# **OBJECTION TO THE PROPOSAL SSD 5752**

## **The Proposal SSD 5752 Sydney International Convention, Exhibition and Entertainment Precinct - Redevelopment of convention centre, exhibition centre, entertainment facilities and associated public domain works**

**Proposed  
June 21 Winter  
9:00am**

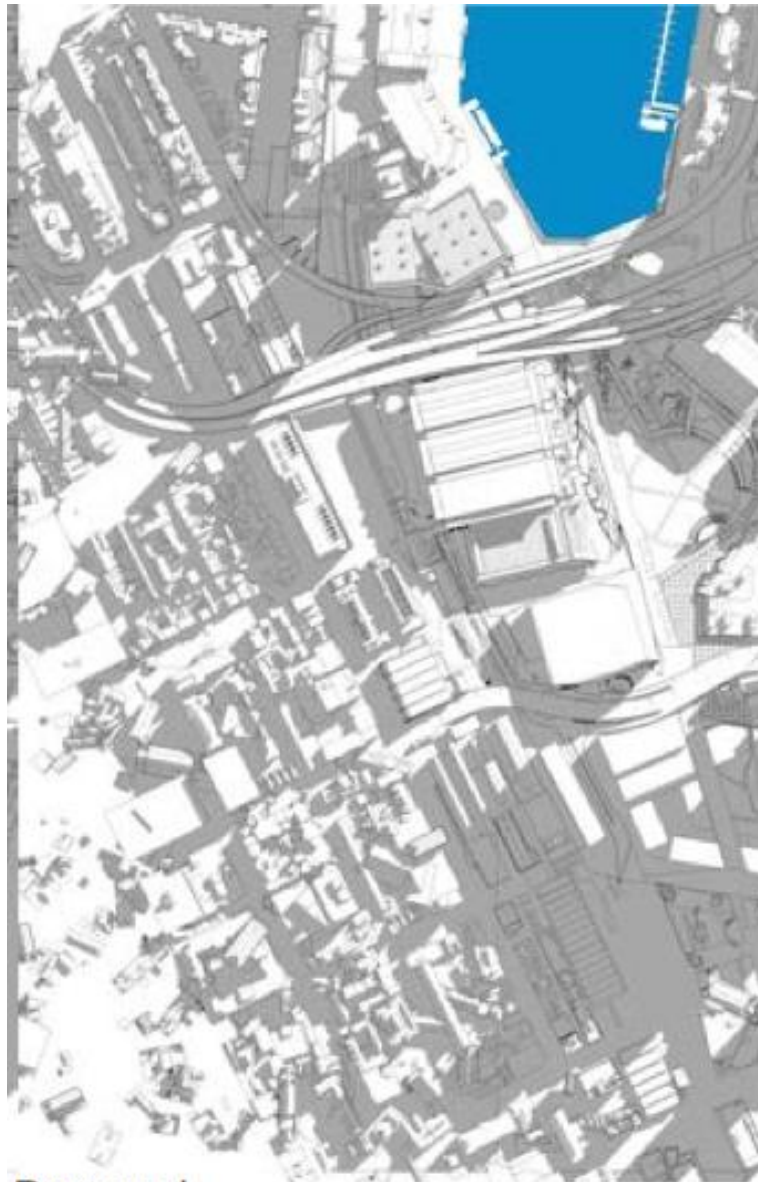
The ICC shadow diagrams show that there will be significant overshadowing of the Goldsbrough from the new ICC and towers, taking away morning sunlight in the all important winter mornings. This will result in increased heating costs for the apartments as well as the loss of valuable morning winter sunlight.

From the Shadow analysis diagrams in the DA it shows a significant loss of sunlight on Pyrmont St in front of the building and the Eastern face of the Goldsbrough in winter. This is in direct contradiction on trying to make Sydney's buildings more environmentally friendly.

See Shadow diagram below from DA submission.

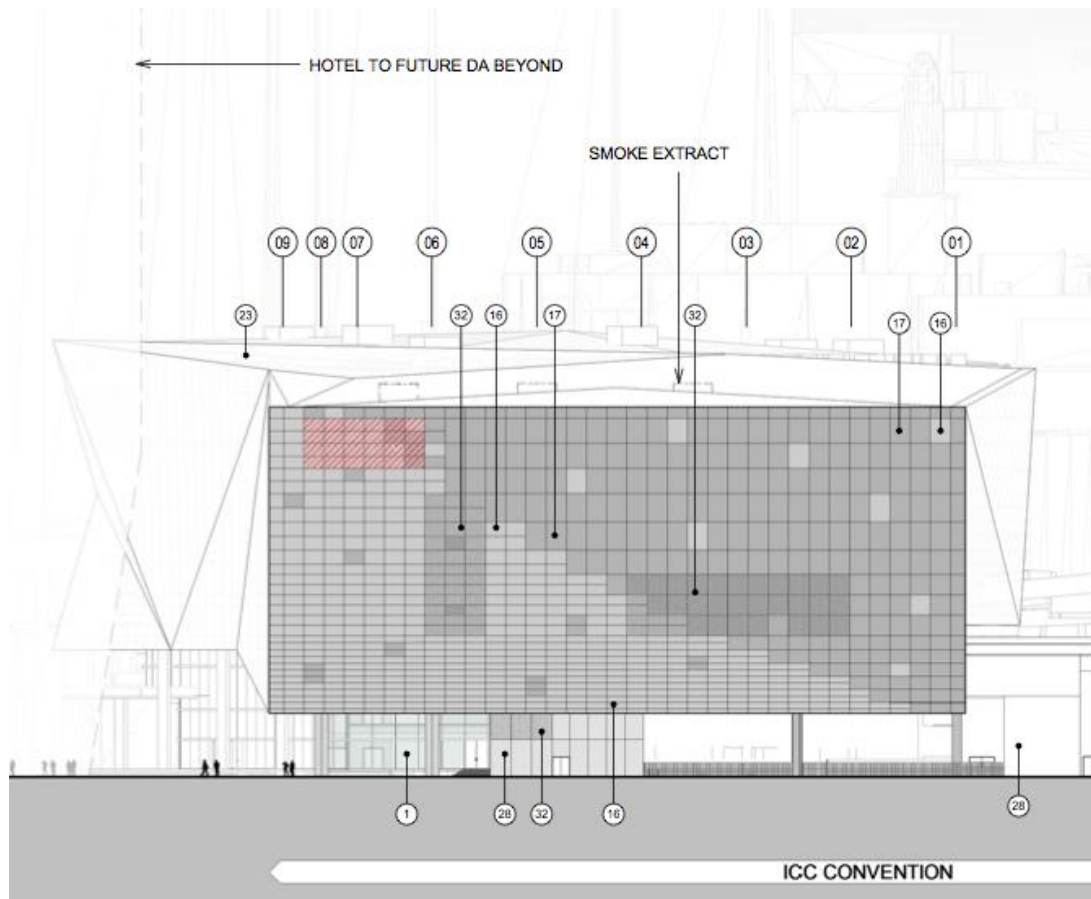
As the height of the proposed ICC is nearly the current height of the Goldsbrough, any outlook from the Goldsbrough to Darling Harbour will be dominated by the Western (rear) face of the ICC. In the DA plans it shows that this will be a Grey metal panel wall which will just look like a Grey metal barricade for the residents and visitors to Goldsbrough building and the visitors walking along Pyrmont Street. The glass frontage is kept for the Eastern (Darling Harbour) face of the building. All the publicity shots show the view of the East face yet all the Goldsbrough residents and the visitors to the area will see is the ugly utilitarian Western face.

See Diagram below for view of the Western face of the ICC facing the Goldsbrough. Note the scale of this wall in relation to the people in the picture.

If a proposal for a building is allowed to go ahead, the proposed ICC building height should be the same level of the existing building and the Western face of the ICC should be architecturally articulated and made of materials (e.g. glass) that don't look like a metal barricade.

The mentioned walkway

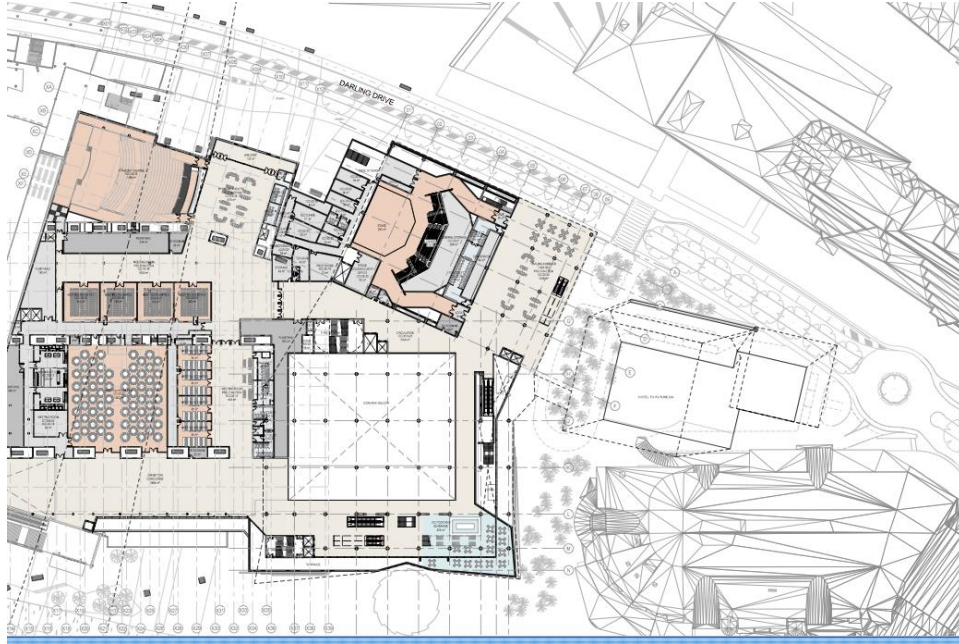
The proposed changes at Darling Harbour seem to take away an extremely important thoroughfare for the residents. From the plans it looks like the current overhead pedestrian walkway next to the Convention monorail station is being removed. Currently it is the easiest and safest walkway to enter the Darling Harbour precinct from the Western side. Currently it is estimated that there are around 7000 pedestrian traffic movements across this walkway on a regular day and many more on busy event days. It is the only safe way to cross the light rail tracks and Darling Drive and is the direct access for 2 major car parks servicing Darling Harbour. This walkway is open 24 hours a day, 7 days a week with continuous public access.

How are pedestrians especially with children and elderly people meant to cross to and from Darling Harbour in a safe way at all hours?

From the Architectural drawings below it shows how the current walkway is removed in the proposed plan
